Access Compliance Report

Public Rights-of-Way

Intersection ID: 10664	Main Street: CHARLES_AV	Cross Street: CLEMSON_AV	Location: SE
ADA ID: 4C5B1D5A0B85	Ramp Type: Perp	Initial Pass/Fail: Fail	Overall Compliance: No
		Severity Score: 50

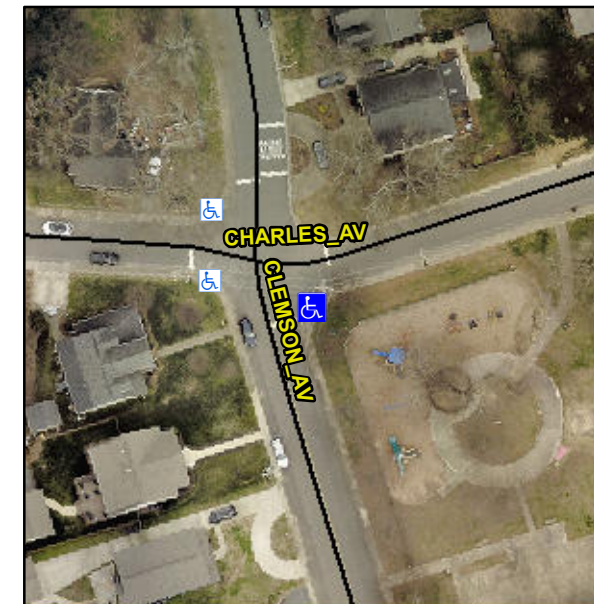
Not Found, R304.2.2, R304.5.3

Compliance	Description	Data	Compliance	Description	Data
N/A	Ramp Length (in)	72.0	No	Ramp Slope (%)	12.1
Yes	Ramp Width (in)	48.0	No	Ramp XSlope (%)	7.2
N/A	Flare Type LT	N/A	N/A	Flare Type RT	N/A
N/A	Flare Slope LT (%)	N/A	N/A	Flare Slope RT (%)	N/A
N/A	Flare Traversable LT?	N/A	N/A	Flare Traversable RT?	N/A
N/A	Landing Length (in)	N/A	N/A	DWS Provided?	N/A
N/A	Landing Width (in)	N/A	N/A	DWS Contrast?	N/A
N/A	Landing Slope (%)	N/A	N/A	DWS Length (in)	N/A
N/A	Landing X Slope (%)	N/A	N/A	DWS Full Width?	N/A
N/A	Landing Curb? (Y/N)	N/A	N/A	DWS Offset (in)	N/A
N/A	Shared Landing?	N/A			
N/A	Gutter Ponding?	N/A	N/A	Gutter Slope (%)	N/A
N/A	Gutter Lip Ht (in)	N/A	N/A	Gutter X Slope (%)	N/A
N/A	Painted X Walk1?	No	N/A	Painted X Walk2?	N/A
	X Walk 1 Direction	To NW		X Walk 2 Direction	N/A
N/A	X Walk 1 Width (in)	N/A	N/A	X Walk 2 Width (in)	N/A
	X Walk 1 Slope (%)	0.3		X Walk 2 Slope (%)	N/A
	X Walk 1 X Slope (%)	3.2		X Walk 2 X Slope (%)	N/A

Remove & Replace Entire Ramp.
